# Product Change Notification (PCN): 0023 Colibri T30 1GB V1.1G and 0030 Colibri T30 1GB IT V1.1B to versions V1.1X

Date of publication: 25 Apr 2023

#### **Change #1: Removal of level shifter**

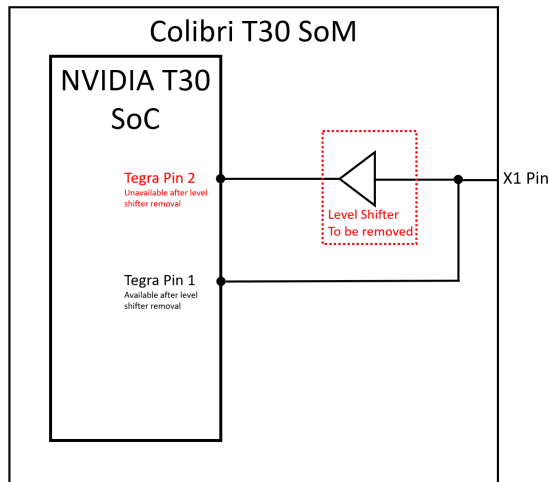
- Removed TI 74AVCA164245ZQLR and related components due to component EOL and shortage

- Parallel camera interface won't be available in V1.1X
- No changes are required on the Colibri carrier board
- SoM Pins affected by this change are : 59, 65, 67, 69, 71, 77, 79, 81, 85, 94, 96, 97, 98, 101, 103  
(see Table 5-18 - Camera Interface Pins in [Colibri T30 datasheet](#))
- All the affected SoM pins multiplexed. They are connected to 2 pins on the SoC-side  
(see Table 4-1 - Colibri Multiplexed Pins in [Colibri T30 datasheet](#))

- The removal of the TI 74AVCA164245ZQLR does not impact the functionality of software, i.e. no errors are displayed
- Coming out of Reset, some of these pins will have the internal pull-up/down enabled (for more details see Section 4.4 - List Functions in [Colibri T30 datasheet](#))
- After boot, If not handled properly, the affected Tegra pins listed above will be left floating as a direct consequence of removing the TI 74AVCA164245ZQLR level shifter. Thus, Toradex strongly recommends enabling the pull-down resistor on these Tegra pins (see related [developer website guide](#))
